Access Compliance Report

Public Rights-of-Way

Intersection ID: N/A	Main Street: BROOKVALE_ST	Cross Street: HORACE_ST	Location: SW
ADA ID: 614004116F67	Ramp Type: Perp	Initial Pass/Fail: Fail	Overall Compliance: No
		Severity Score: 12.5

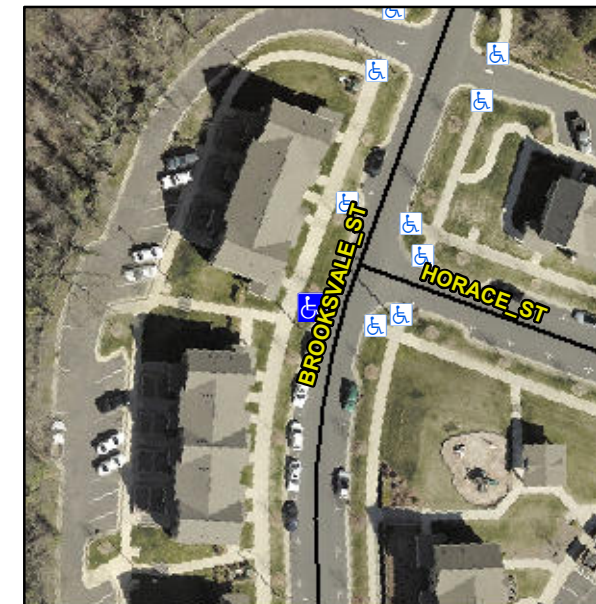
R304.2.2

Compliance	Description	Data	Compliance	Description	Data
N/A	Ramp Length (in)	72.0	No	Ramp Slope (%)	8.7
Yes	Ramp Width (in)	70.0	Yes	Ramp XSlope (%)	1.0
N/A	Flare Type LT	N/A	N/A	Flare Type RT	N/A
N/A	Flare Slope LT (%)	N/A	N/A	Flare Slope RT (%)	N/A
N/A	Flare Traversable LT?	N/A	N/A	Flare Traversable RT?	N/A
N/A	Landing Length (in)	N/A	N/A	DWS Provided?	N/A
N/A	Landing Width (in)	N/A	N/A	DWS Contrast?	N/A
N/A	Landing Slope (%)	N/A	N/A	DWS Length (in)	N/A
N/A	Landing X Slope (%)	N/A	N/A	DWS Full Width?	N/A
N/A	Landing Curb? (Y/N)	N/A	N/A	DWS Offset (in)	N/A
N/A	Shared Landing?	N/A			
N/A	Gutter Ponding?	N/A	N/A	Gutter Slope (%)	N/A
N/A	Gutter Lip Ht (in)	N/A	N/A	Gutter X Slope (%)	N/A
N/A	Painted X Walk1?	No	N/A	Painted X Walk2?	N/A
	X Walk 1 Direction	To SE		X Walk 2 Direction	N/A
N/A	X Walk 1 Width (in)	N/A	N/A	X Walk 2 Width (in)	N/A
	X Walk 1 Slope (%)	2.2		X Walk 2 Slope (%)	N/A
	X Walk 1 X Slope (%)	0.4		X Walk 2 X Slope (%)	N/A

Remove & Replace Entire Ramp.
